DESIGN & ACCESS STATEMENT ADDENDUM

THE OLD DAIRY, LONDON

MAY 2017

Lower Ground Floor Plan

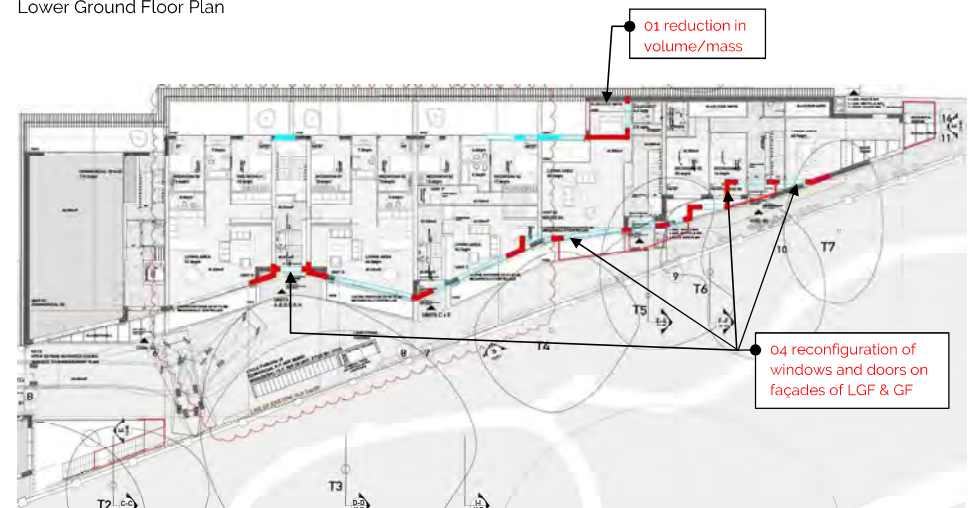
01. Reduction in building volume at rear facade
 - For reconfiguration of units, 10 sq.m on each floor at rear façade has been removed in order to increase the level of daylight to Townhouse-1, as well as to give it a courtyard space at Lower Ground Floor.
 - It results in a reduction in built form at the rear of the building.
02. Reduction in building volume at rear facade
 - For reconfiguration of units, 10 sq.m on each floor at rear façade has been removed in order to increase the level of daylight to Townhouse-1, as well as to give it a courtyard space at Lower Ground Floor. It results in a reduction in built form at the rear of the building.

Ground Floor Plan

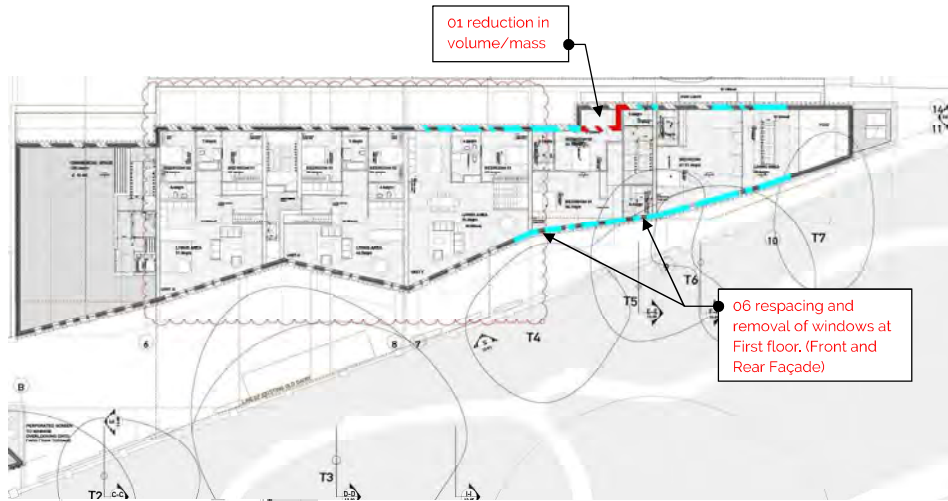
- Modification to window spacing
- Modification to building exterior line

First Floor Plan

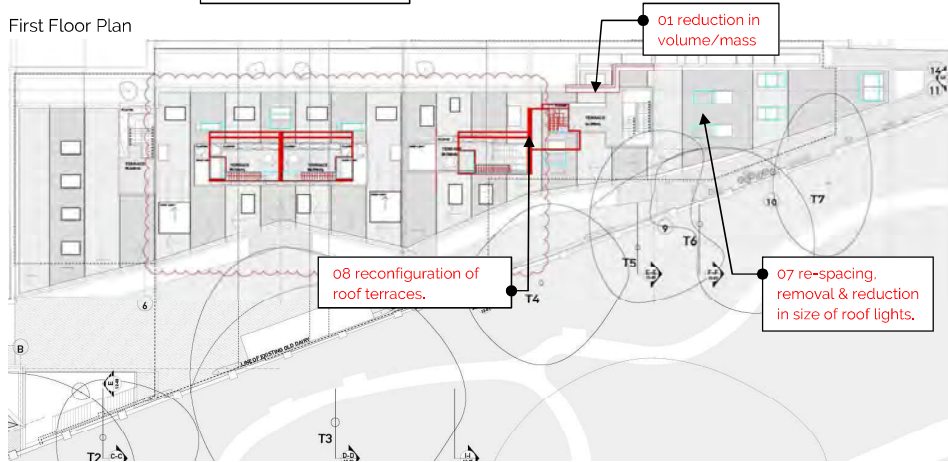
03. Reduction in building volume at rear façade

- For reconfiguration of units, 10 sq.m on each floor at rear façade has been removed in order to increase the level of daylight to Townhouse-1, as well as to give it a courtyard space at Lower Ground Floor.
- It results in a reduction in built form at the rear of the building.

04. Footprint re-alignment at Lower Ground Floor

- To rationalise the footprint at Lower Ground floor.
- There is no impact above ground. The interior space will be more usable space at Lower Ground.

05. Reduction in built area at Lower Ground floor and addition of light well

- To provide more usable internal space with improved natural daylight and access to external space at Lower ground floor.
- Small light well in lieu of walk on skylights it is not overlooked or visible from surrounding areas.

06. Reconfiguration of windows and front doors on façades of Lower Ground and Ground floor

- A number of windows at Basement and Ground floors have been re-positioned on both front and rear façades to suit the revised internal layouts.
- The front doors to the front façade at Ground floor level are rearranged to suit revised internal layouts.
- The above changes will have no impact on the surroundings. They are not visible from outside the site as they are hidden behind perimeter boundary walls.

07. Removals of windows on façade of the commercial area 1 at First floor

- One window is removed at first floor (at Western end) of commercial area 1 to suit internal layout.
- The changes will have no material impact on the appearance of the building or on the character of the surrounding neighbouring gardens.

08. Re-spacing and removal of windows on front & rear façades at First floor

- The planning approved façades at first floor have a series of vertical slot windows to the front and rear. A number of these same sized windows will be re-positioned to suit the internal layout towards the Eastern end of the building. These are same sized windows as approved planning scheme, so no additional overlooking.
- Those windows at the front will follow the same rhythm as the planning approved scheme. The changes will have no material impact on the appearance of the new building or on the character of the surrounding neighbouring gardens and conservation area. The windows at the rear will again follow the same pattern of the existing layout and will be barely discernible from outside the site due to the existing perimeter gable walls, which are being retained.

-
- The removal of 1 window is positive as it reduces the perceived overlooking within the garden. Again these will have no impact on the appearance of the new building, setting of the adjoining listed buildings, and character of the conservation area.

09. Re-spacing, removal & reduction in size of roof lights

- To suit the new internal layouts, it is proposed to remove 10 roof lights and 4 roof lights are re-positioned.
- 3 roof lights are reduced in size to suit the new configuration of roof-terraces.
- It is considered that they will not affect the appearance of the scheme and surroundings.

10. Reconfiguration of roof terraces.

- There are 4 inset roof terraces above the Flats and House- 1 in the planning approved scheme. These will be reconfigured above flats in terms of their shape and staircase access. They do not project further towards the front or rear facades than the current approved design. The 4th terrace will be moved upon Flat K in lieu of house-1. This will be away from the East side of the site, which is an improvement to the perceived overlooking issue to the gardens.
- It is considered that they will continue to be small discreet features which do not affect the appearance of the scheme and surroundings.
